CERTIFICATE OF APPROPRIATENESS

Property: 4628 Oakridge Street, Lot 6, Block 113, North Norhill Subdivision. The property includes a historic 969 square foot, one-story wood frame single-family residence and a detached shed situated on a 5,000 square foot (50' x 100') interior lot.

Proposal: New Construction – Construct a rear 1-story addition with an attached carport to an existing 1-story residence.

WEST ELEVATION – FRONT FACING OAKRIDGE STREET

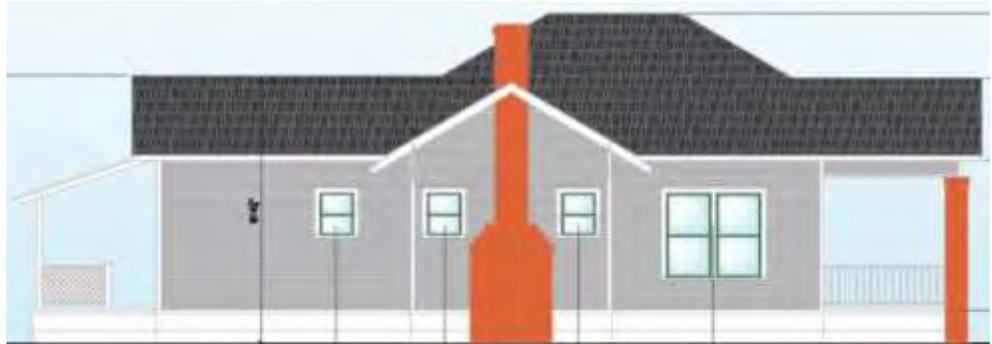
The existing original wood 3-lite front entry door be retained.

<i>The replacement of the existing original 3-lite wood paneled entry door result in the loss of significant historic material.</i> | |

HAHC Action: Approved with Conditions: The existing original wood 3-lite front entry door be retained.

SITE PLAN

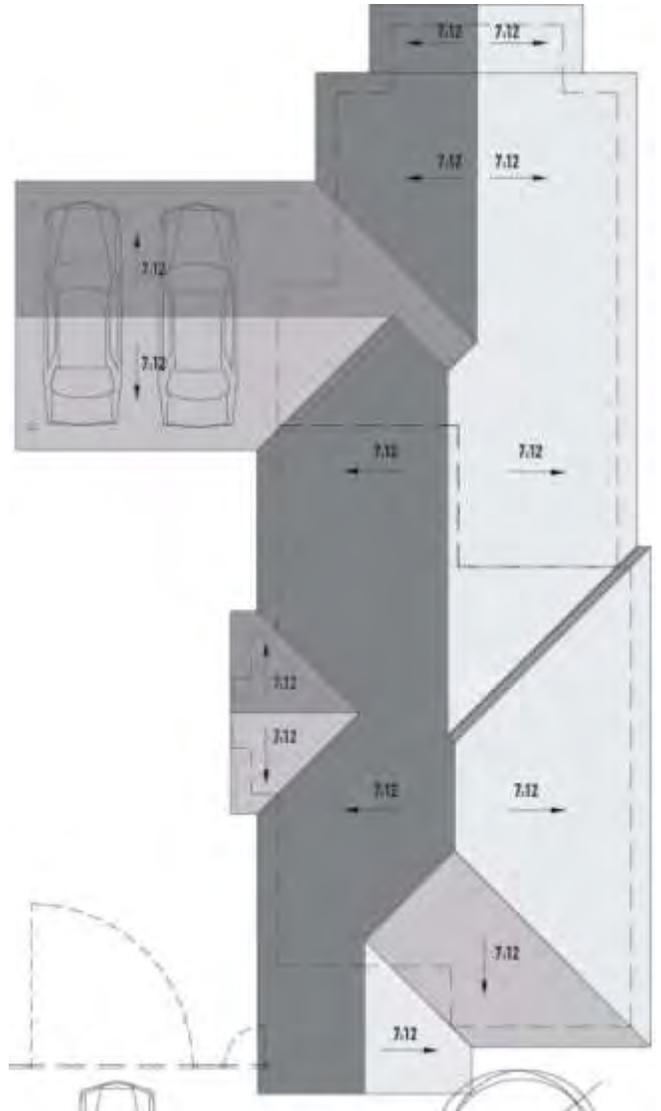
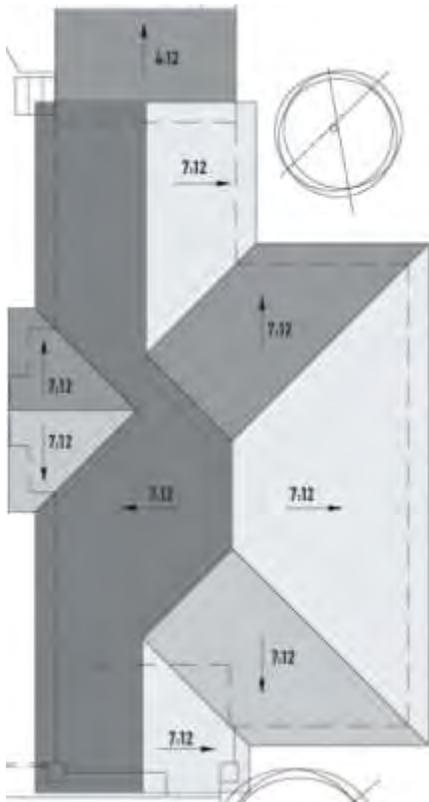
Thanks for your submission. Our next meeting is Aug 13th. At first glance I see several problems with this addition. Carports/garages must be detached and 60 ft back from front property line. Also the distance between the back property line and your proposed rear addition will need to be discussed.
